Access Compliance Report

Public Rights-of-Way

(Curb Ramps)

Intersection ID: 11712	Main Street: ALLEN_ST	Cross Street: E_20TH_ST	Location: W
ADA ID: 11DF5514E96E	Ramp Type: PerpDiag	Initial Pass/Fail: Fail	Overall Compliance: No
		Severity Score: 1.25

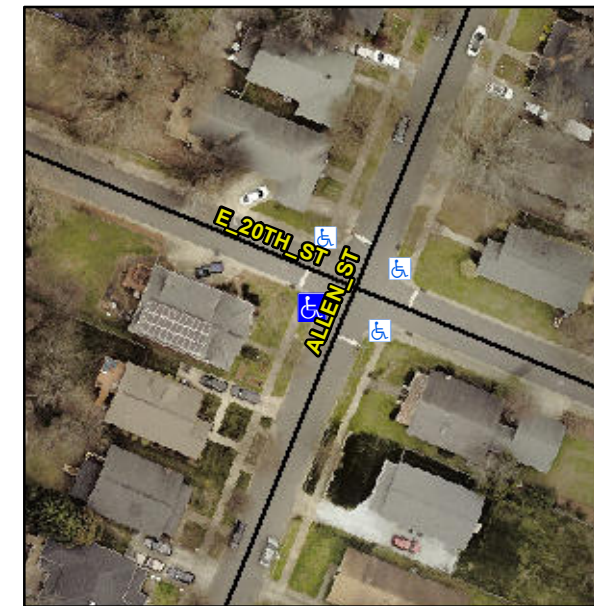
Not Found, R304.5.3

Compliance	Description	Data	Compliance	Description	Data
N/A	Ramp Length (in)	72.0	Yes	Ramp Slope (%)	6.3
Yes	Ramp Width (in)	48.0	No	Ramp XSlope (%)	4.2
N/A	Flare Type LT	N/A	N/A	Flare Type RT	N/A
N/A	Flare Slope LT (%)	N/A	N/A	Flare Slope RT (%)	N/A
N/A	Flare Traversable LT?	N/A	N/A	Flare Traversable RT?	N/A
N/A	Landing Length (in)	N/A	N/A	DWS Provided?	N/A
N/A	Landing Width (in)	N/A	N/A	DWS Contrast?	N/A
N/A	Landing Slope (%)	N/A	N/A	DWS Length (in)	N/A
N/A	Landing X Slope (%)	N/A	N/A	DWS Full Width?	N/A
N/A	Landing Curb? (Y/N)	N/A	N/A	DWS Offset (in)	N/A
N/A	Shared Landing?	N/A			
N/A	Gutter Ponding?	N/A	N/A	Gutter Slope (%)	N/A
N/A	Gutter Lip Ht (in)	0.5	N/A	Gutter X Slope (%)	N/A
N/A	Painted X Walk1?	No	N/A	Painted X Walk2?	No
	X Walk 1 Direction	To SE		X Walk 2 Direction	To NE
N/A	X Walk 1 Width (in)	N/A	N/A	X Walk 2 Width (in)	N/A
	X Walk 1 Slope (%)	4.2		X Walk 2 Slope (%)	1.1
	X Walk 1 X Slope (%)	1.3		X Walk 2 X Slope (%)	3.0

Remove & Replace Curb Ramp With Two New Directional Ramps or Equivalent.
